Exhibit B

Recommended Amendments to the 2018 International Residential Code City of Amarillo, Texas

*****Figure R602.6.1; delete the figure and insert the following figure:**

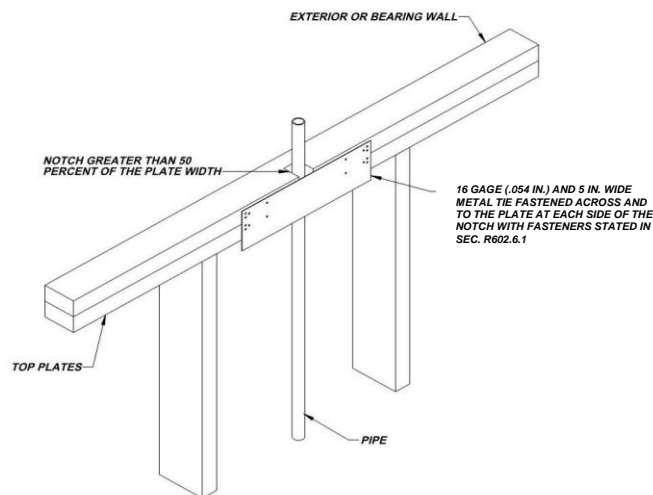
*****Section R602.6.1; amend the following:**

R602.6.1 Drilling and notching of top plate. When piping or ductwork is placed in or partly in an exterior wall or interior load-bearing wall, necessitating cutting, drilling or notching of the top plate by more than 50 percent of its width, a galvanized metal tie not less than 0.054 inch thick (1.37 mm) (16 Ga) and 4 ½ inches (38 mm) 5 inches (127 mm) wide shall be fastened across and to the plate at each side of the opening with not less than eight 10d (0.148 inch diameter) nails having a minimum length of 1½ inches (38 mm) or eight (#10) wood screws having a minimum length of not less than 1½ inch (38 mm) at each side or equivalent as approved by the Code Official. Fasteners will be offset to prevent splitting of the top plate material. The metal tie must extend a minimum of 6 inches past the opening. See figure R602.6.1. {Remainder unchanged}

(Reason: Amendment to provide additional assurance of maintaining the integrity of the framing by spreading the nailing/screw pattern.)

FIGURE R908.3.1.1 HAIL EXPOSURE MAP

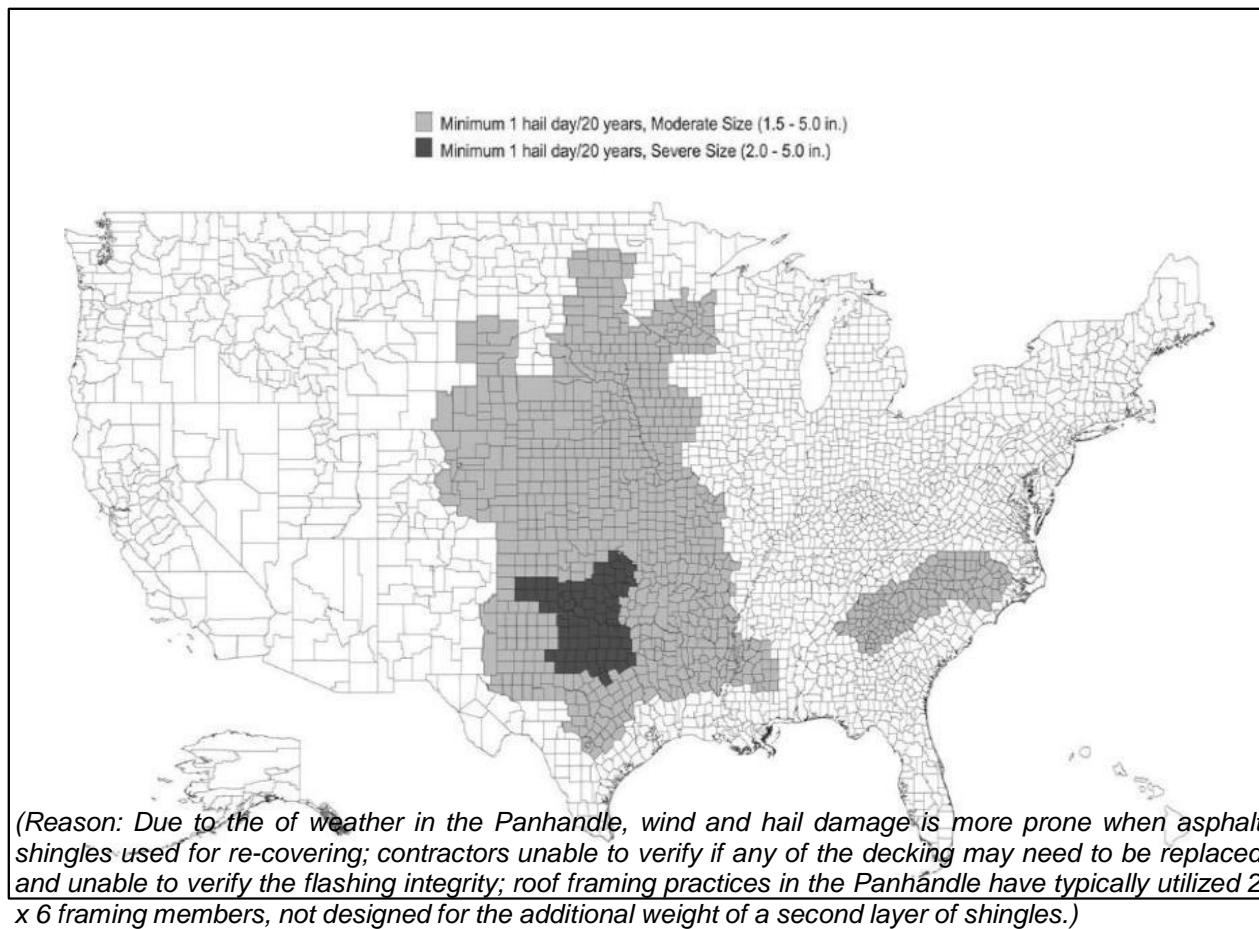
****Section R908.3.1.1; insert Figure R908.3.1.1; change to read as follows:**

R908.3.1.1. A roof re-cover shall not be permitted where any of the following conditions occur:

1. Where the existing roof or roof covering is water-soaked or has deteriorated to the point that the existing roof or roof covering is not adequate as a base for additional roofing.
2. Where the existing roof covering is wood, slate, clay, cement or asbestos-cement tile.
3. Where the existing roof has two or more applications of any type of roof covering.
4. For asphalt shingles, when the building is located in an area subject to moderate or severe hail exposure according to Figure R908.3.1.1.
